Technical News Bulletin

April 12th, 2008

SI Replacement Monitor

Figure 1: View of Keyboard module showing location of EPROMs

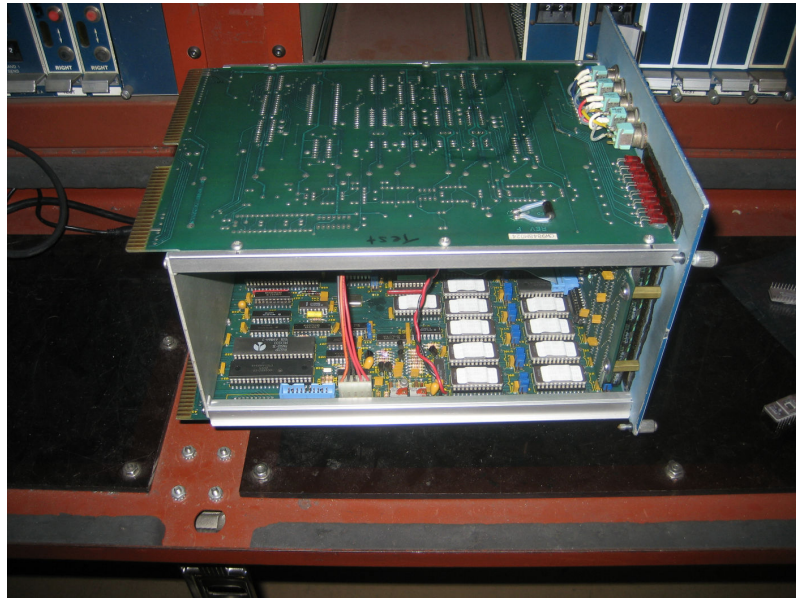
Due to various obsolescence issues, the 919520002 SI monitor is no longer available. In order to replace this monitor, the software that runs the SI had to be changed. The software change is minor and will not affect the operation of the machine; it will, however, require the replacement of an EPROM. In order to ensure that the correct monitor replacement kit is ordered, the current software version must be cross referenced with the table below. From this, the correct version of the 26746A SI Replacement Monitor kit can be ordered.

The SI Replacement Monitor Kit will contain 2 items: the replacement monitor and an EPROM. The installation of the monitor is straightforward and identical to previous replacements. The EPROM will contain the new software and will have to be installed in the SI's keyboard module. The procedure to replace the EPROM is included in the Kit's instructions and is duplicated below for convenience.
